Attachment B: Illustration of Recommended Dedications
Right-of-Way Dedications

**Public Works Referral Response
Tentative Planned Unit Development – General Criteria**

Date: 9/17/13
To: Becky Taylor, Planning
From: Ed Haney, Public Works
Subject: PDT13-01 Oakleigh Cohousing PUD

Attachment D-5 Street Connectivity

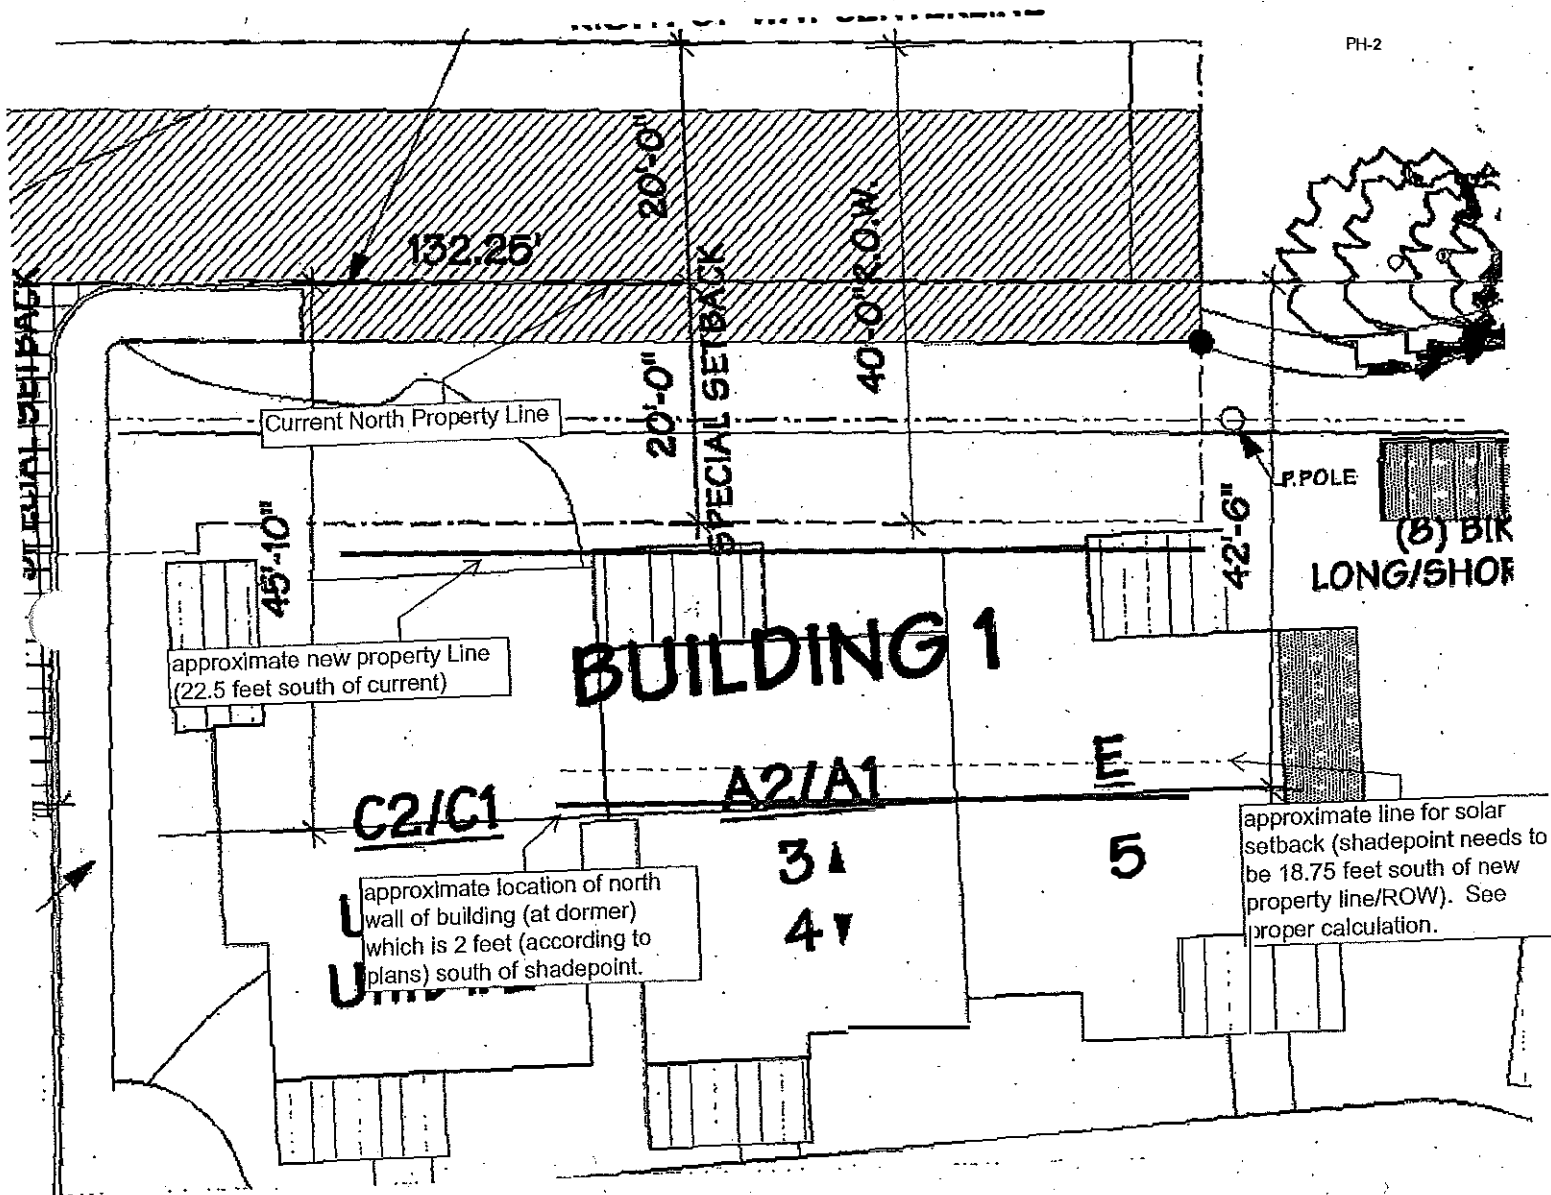
The applicant's alternate street study (Figure 1, Attachment D-5) identifies the amount of right-of-way necessary to construct an emergency vehicle turnaround at the end of Oakleigh Lane, and to provide the necessary frontage for flag lot development of undeveloped adjacent lands to the north (Tax Lot 200). Public Works staff indicates that the applicant's proposal is sufficient to accommodate the turnaround, but not the area necessary to extend the sidewalk along the south side of the turnaround, to separate pedestrians from vehicles and provide a safe public walking surface for the residents of the proposed development. The amount of right-of-way necessary to allow for the construction of the proposed turnaround and adjacent sidewalk would be a strip that is 13 feet wide by 199 feet in length. These dimensions assume that the turnaround would be 21 feet wide and that the north edge of the turnaround would match the existing edge-of-pavement in Oakleigh Lane, which is shown on the tentative plans as being six feet south of the existing right-of-way. The addition of a six-inch curb, five-foot sidewalk, and six inches behind the sidewalk, as necessary for construction purposes, results in the need for a total of 33 feet of right-of-way (for the future hammerhead turnaround at the east end of Oakleigh Lane), 13 feet of which is within the bounds of the proposed development (with the balance coming from the northerly property, whenever that property decides to develop). Construction of the hammerhead turnaround is not necessary or feasible at this time; the need will be based on further development of adjacent lands to the north. The right-of-way secured with this development will enable future development of that northerly property.

Per Figure 1 of the alternate street plan, TL 200 could be developed with 4 Lots, with Lots 1-3 being created as flag lots from the terminus of the public right-of-way, *i.e.* an emergency vehicle turnaround, and Lot 4 having frontage along the right-of-way. Per Fig. 1, a minimum right-of-way dedication would be 9', however as discussed at EC 9.6870, a right-of-way width of 13' would be necessary to ensure the construction of a public sidewalk adjacent to the south side of the turnaround. Staff confirms that the proposed turnaround would adequately meet the future frontage requirements for development of TL 200.
